## Technical change to M12 plastic nuts

-	PCN-number	PCN-PB46-20190724-00-A
-	date of publishing	24.07.2019
-	revision number	A

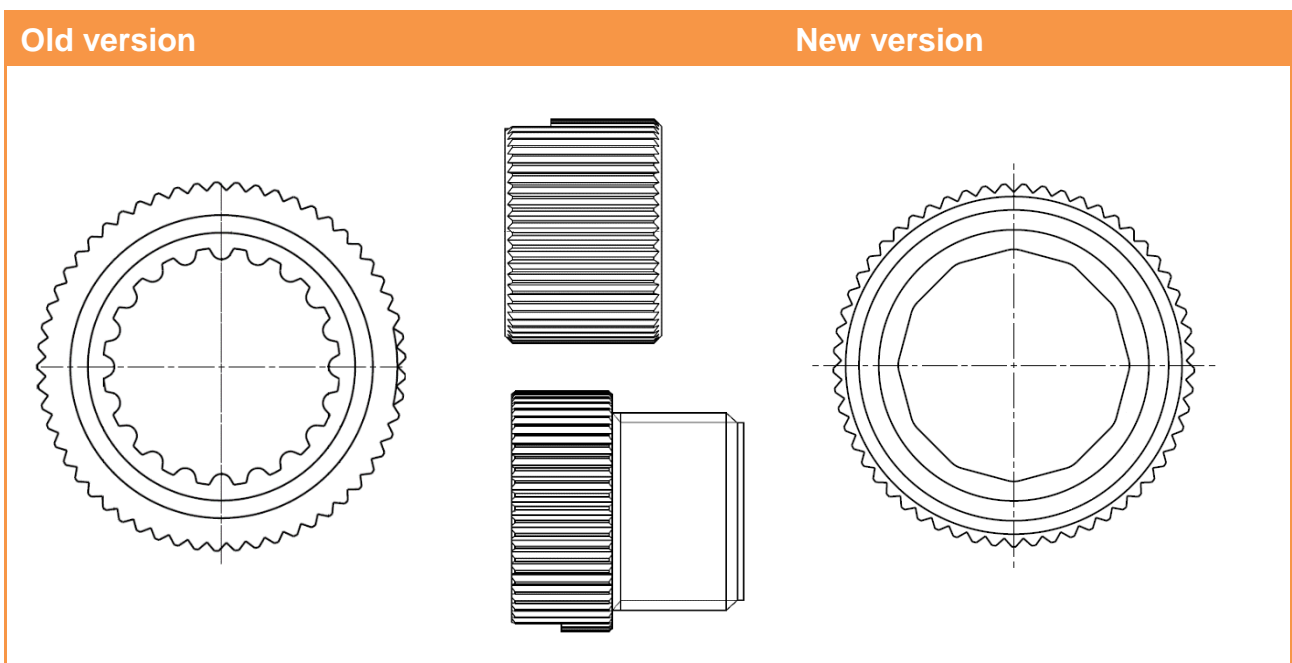
The inner contour of the M12 nut, for vibration protection, is optimized from a toothed ring (old version) to a dodecagon (12-sided). The dimensions and the external design remain unchanged. By changing the inner contour, the tightening torque of the M12 nut is reduced from 0.9 - 1.1 Nm to 0.6 - 0.8 Nm, with the same level of vibration protection.
